SUNDRY NOTICES AND REPORTS ON WELLS

8. Well Name and No.
Dale H. Parke A Tract 1 #24

Dale H. Parke A Tract 1 #24 Deepening Program

Dale H. Parke A Tract 1 #24
Premier Oil & Gas Inc.
30-015-31070
May 10, 2013
Conditions of Approval

Centralizer Diagram

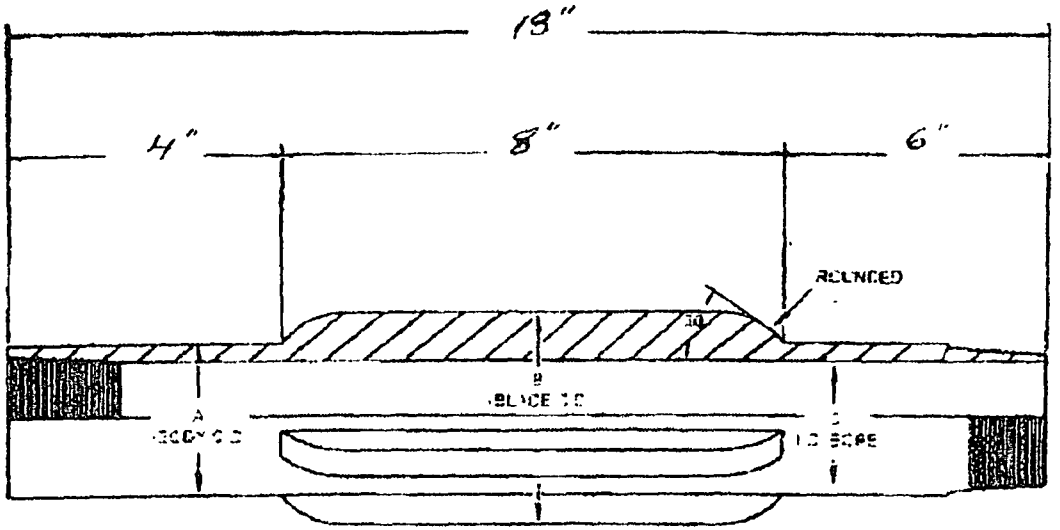
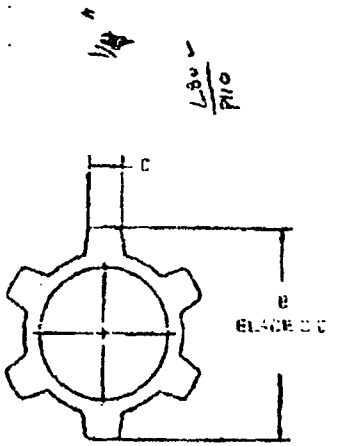
**Due to casing shortages, either L-80 or P-110 will be run. The exact grade is unknown at time of requesting permit.
NOTE: Premier Oil & Gas Inc. requests a variance to the 0.422" stand-off rule between casing and wellbore.

11. Centralizer Program
Fixed blade stabilizer subs will be utilized in the casing string to insure adequate isolation and seal throughout the wellbore. These stabilizer subs are positive fixed blade type. These subs will actually be screwed into the casing string. A diagram of the fixed blade stabilizer sub is located at the end of this program.

5. BOP to be tested to **1000 psi** based on BHP expected.
6. Variance for stand-off of less than 0.422" is approved due to NMOCD classifying the formations in this area as the Yeso group.
